Addendum No. 01

Subject: Edwin Forrest Elementary School – Fire Alarm System Replacement
SDP Contract No. B-008 (C) of 2017/18

This Addendum 01, dated January 30, 2018 shall modify and become part of the Contract Documents for the work of this project. Any items not mentioned herein, or affected by, shall be performed strictly in accordance with the original documents.

DRAWING NO.
ED100

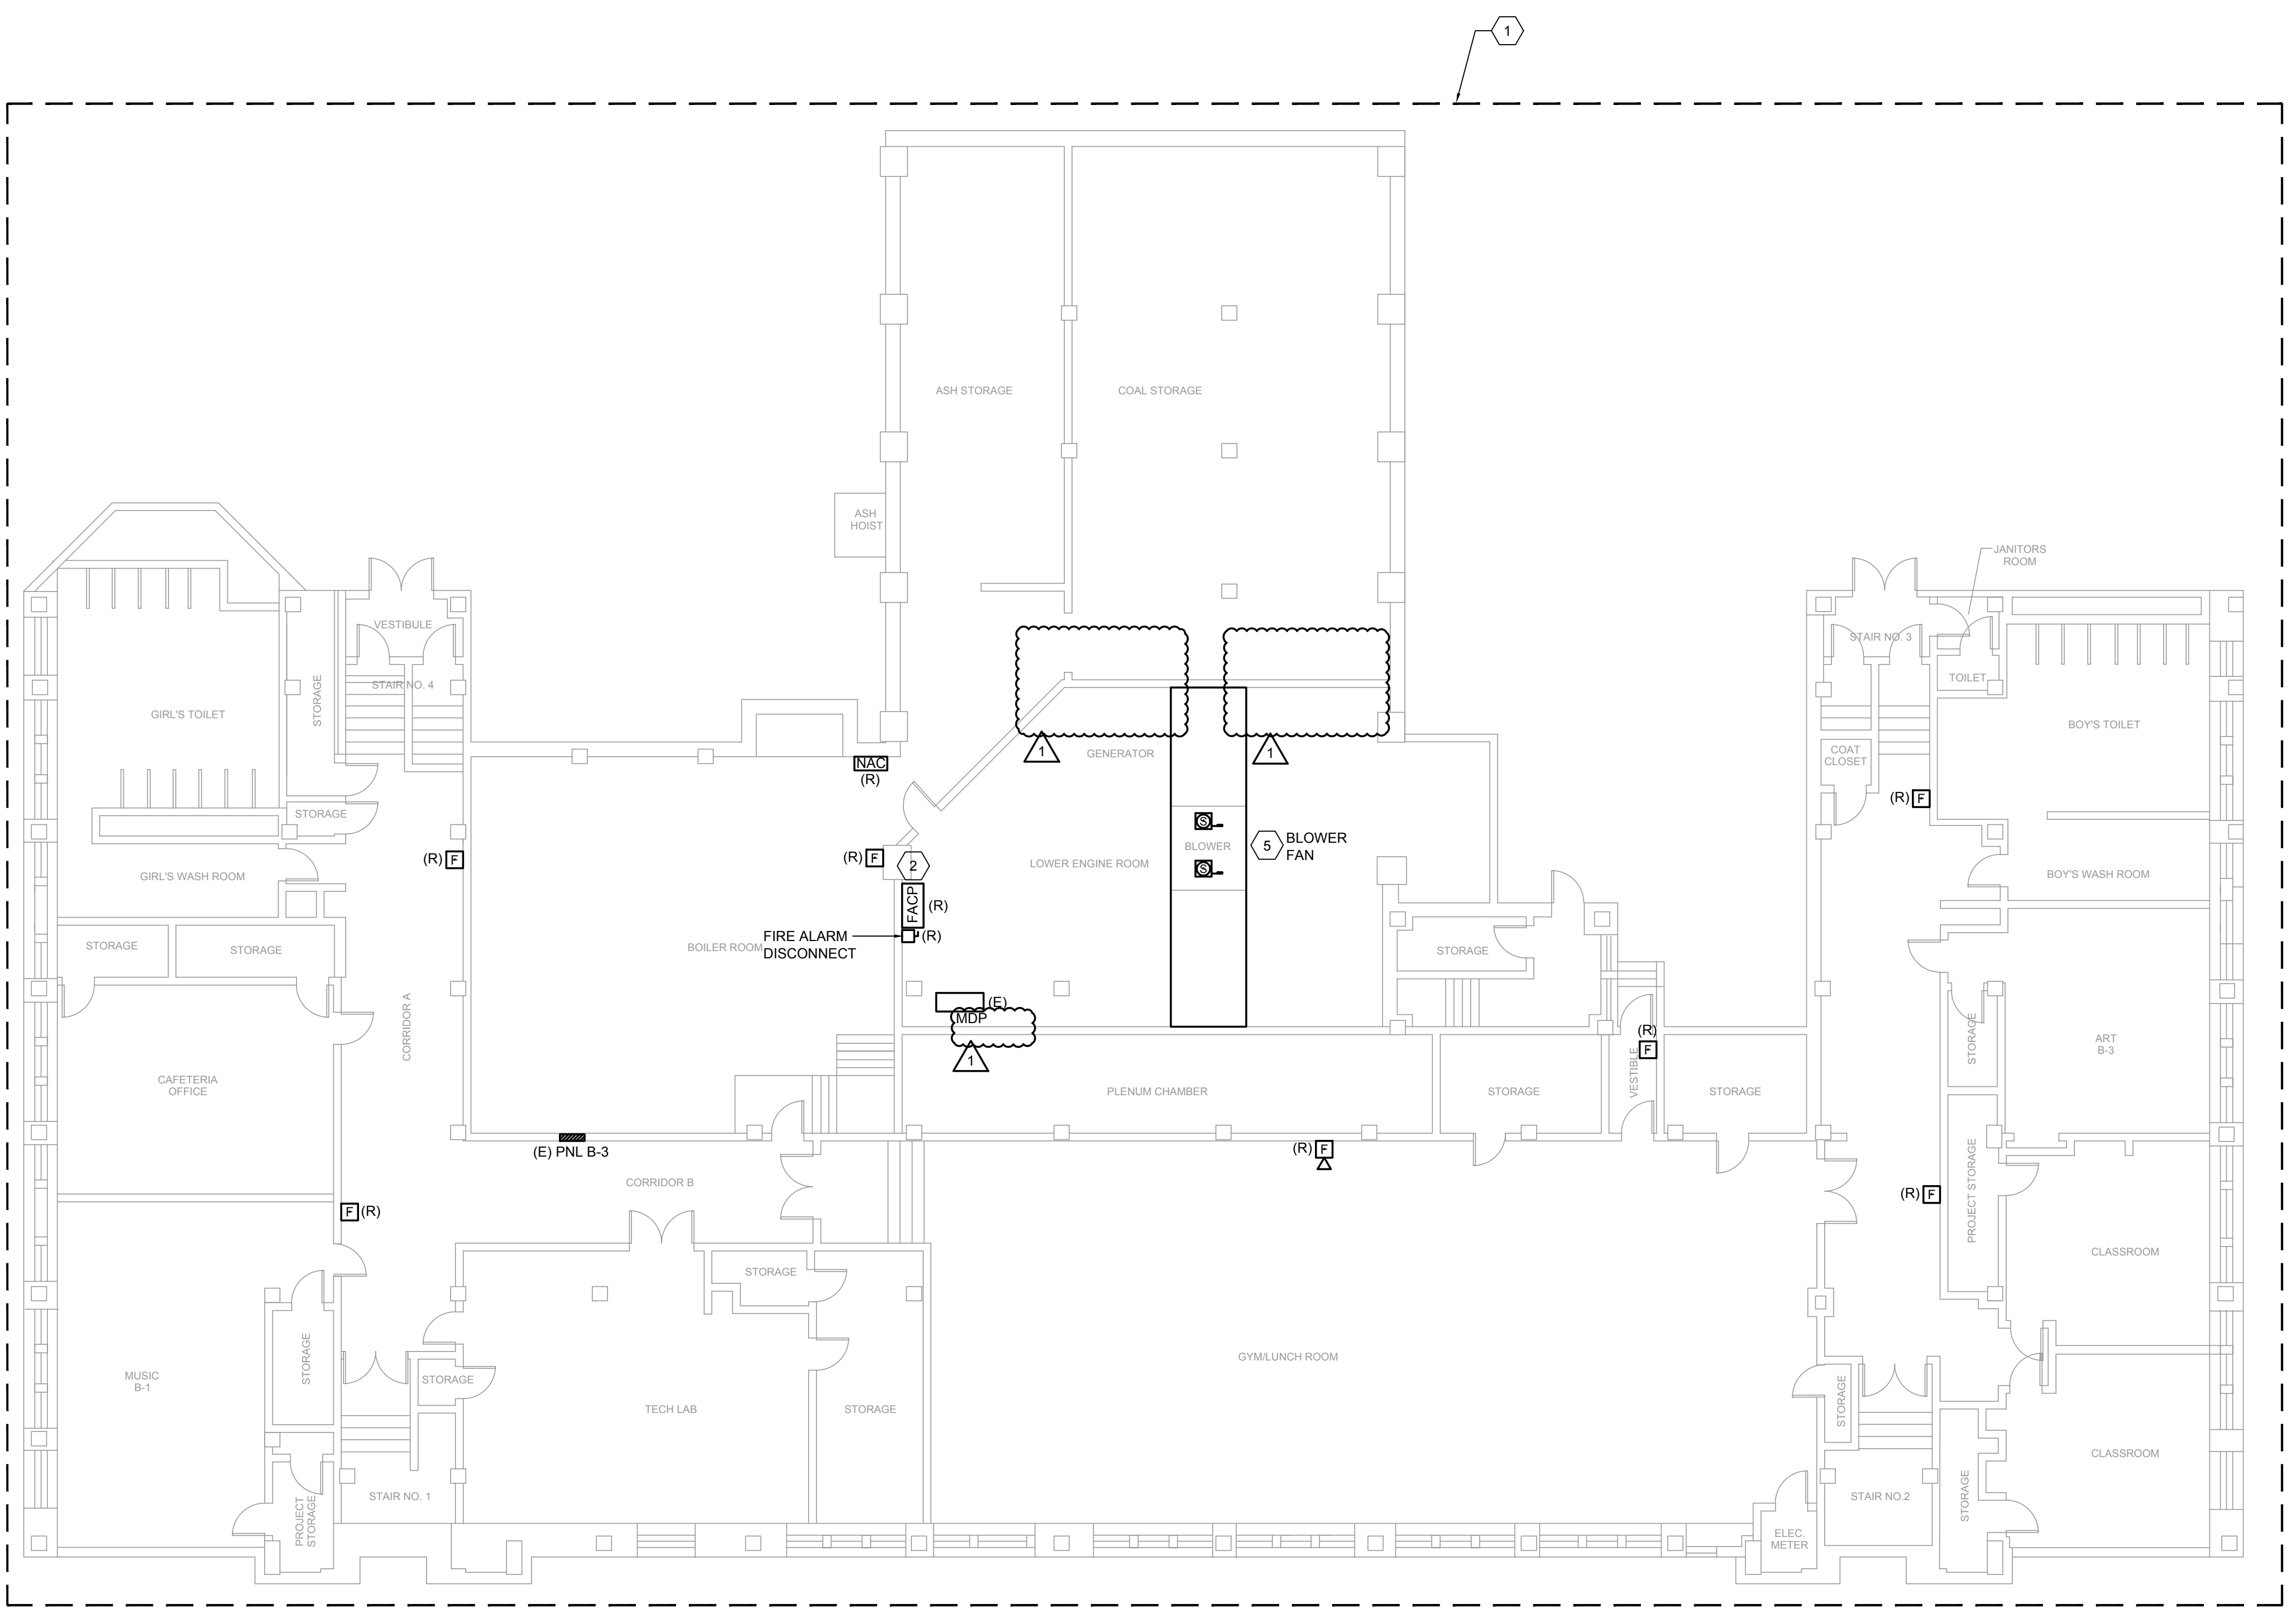
Drawing ED100 – Removed Keynote #3 and #4. Removed scope of work for motor replacement.

| FIRE ALARM KEY NOTES | |
|----------------------|--|
| 3 | NOT USED. |
| 4 | NOT USED. |

DRAWING NO.
E100

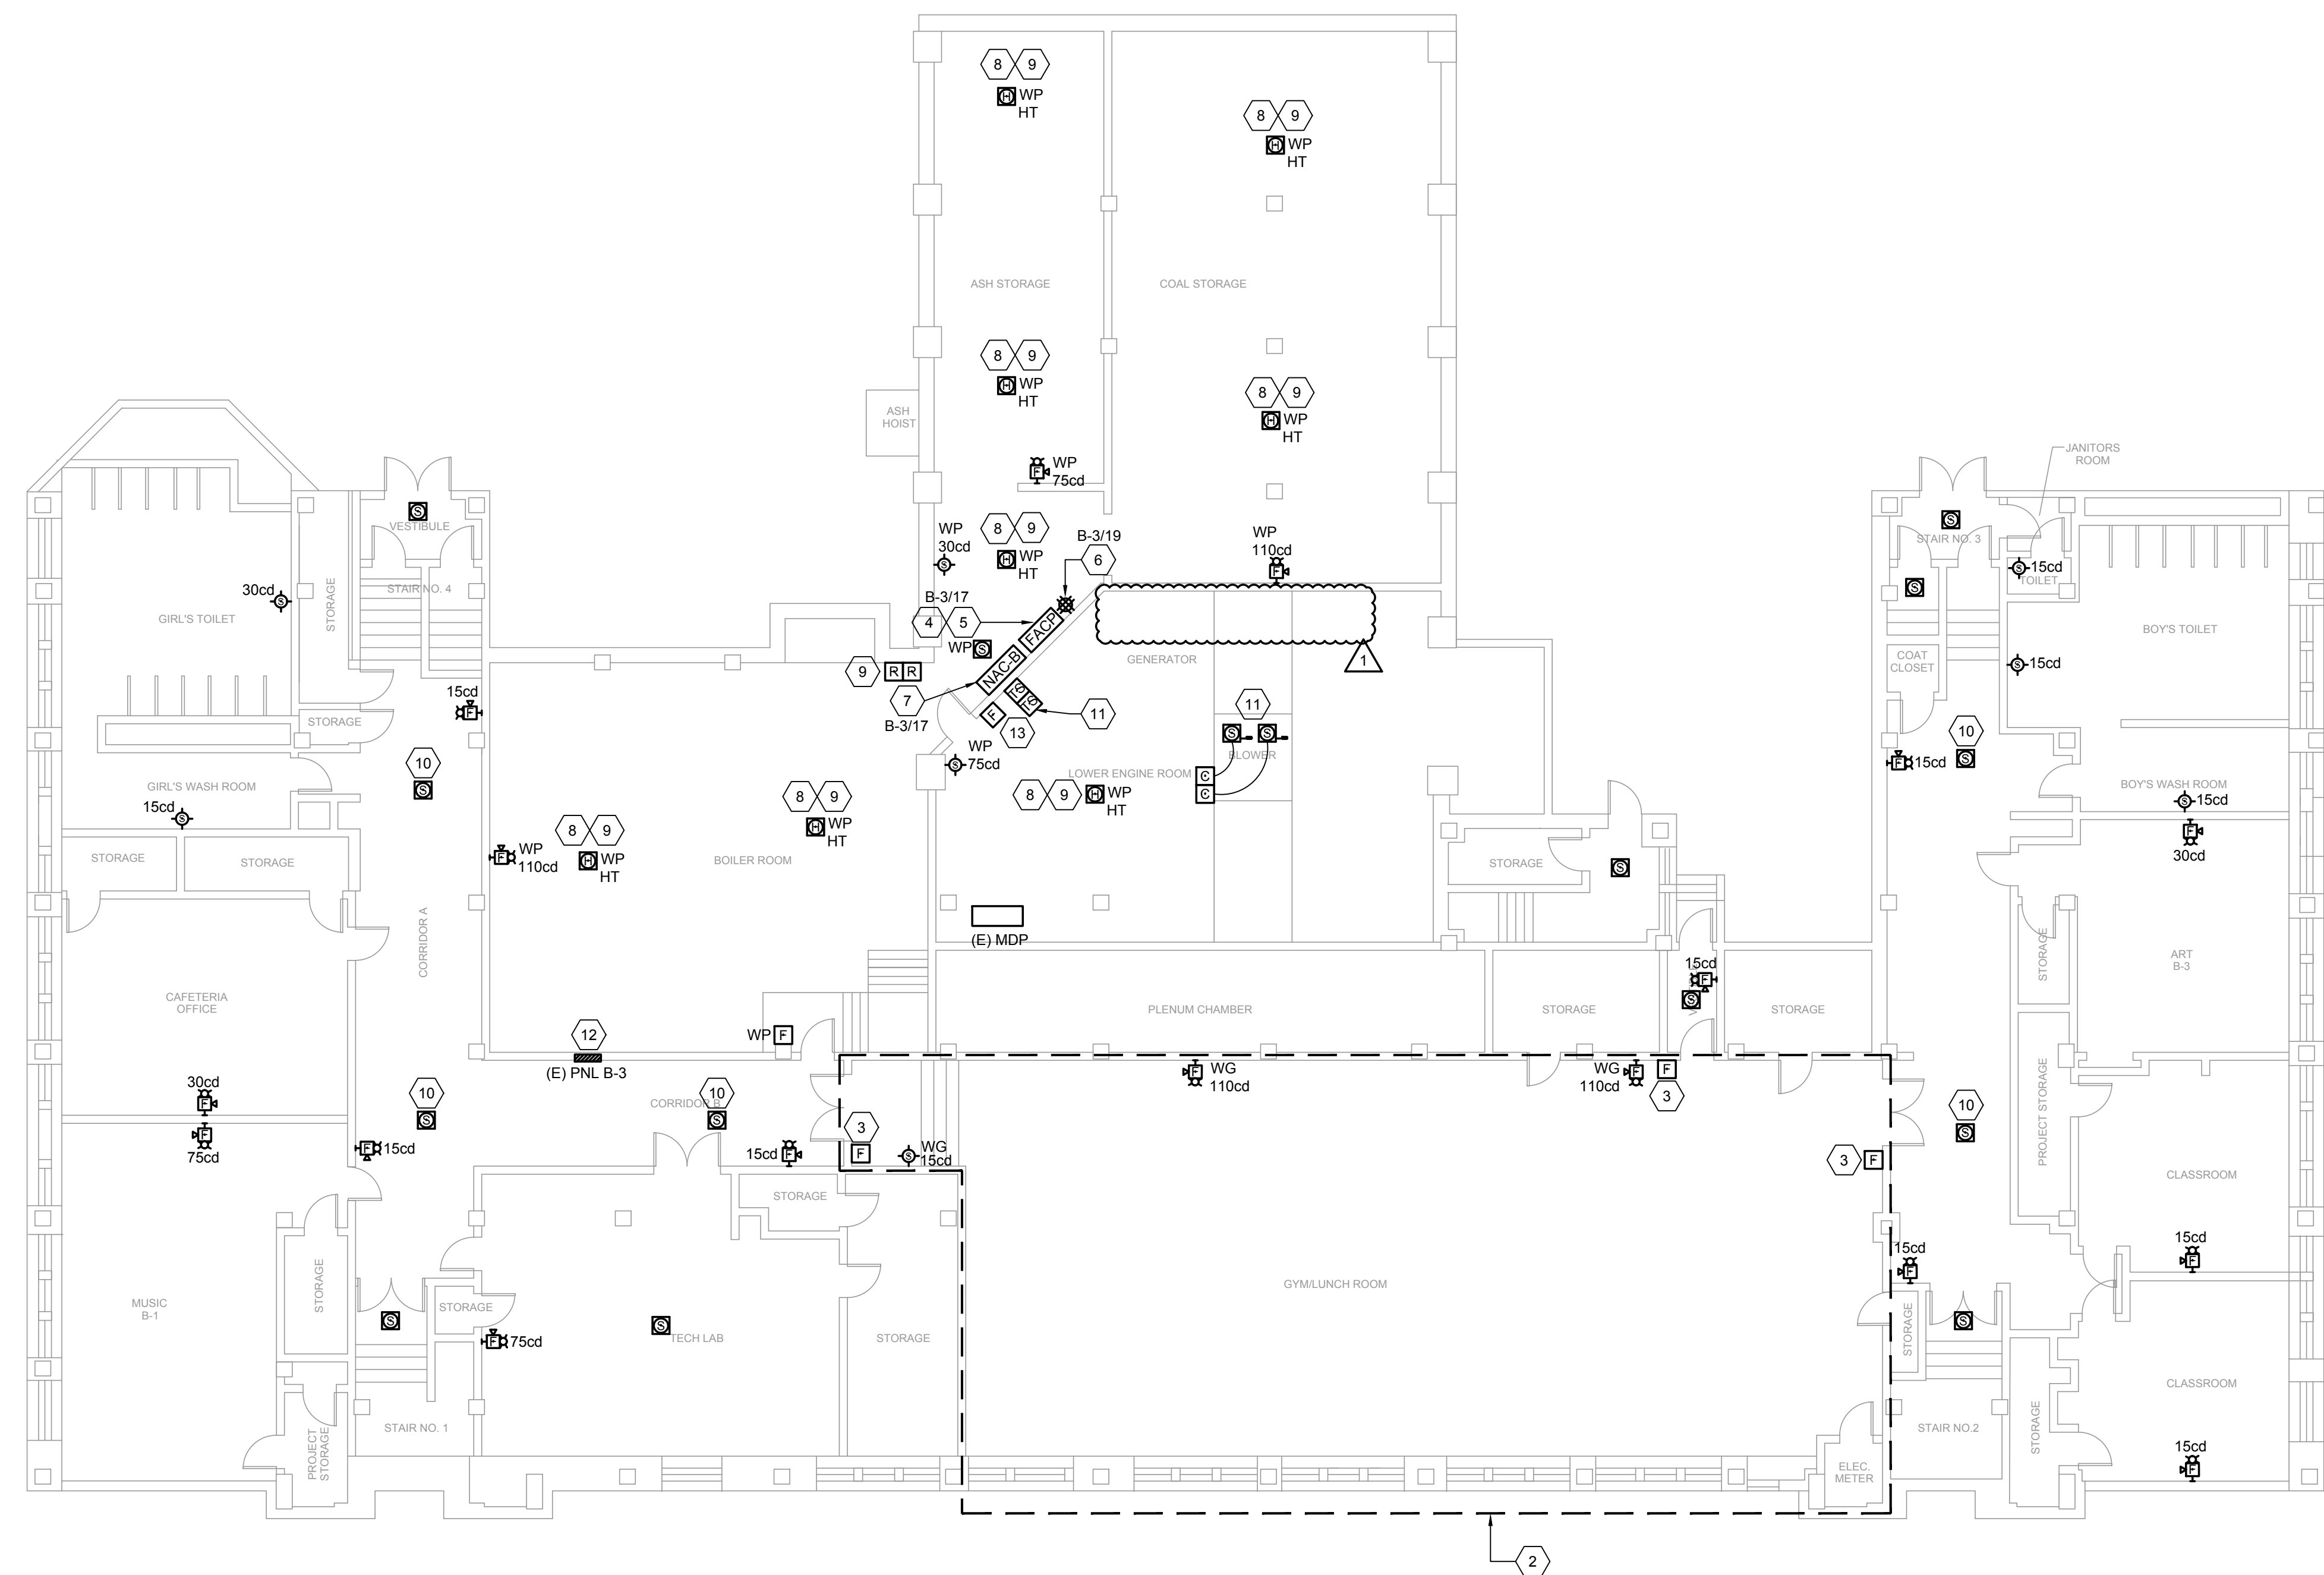
Drawing E100 – Removed Keynote #14 and #15. Removed scope of work for motor replacement.
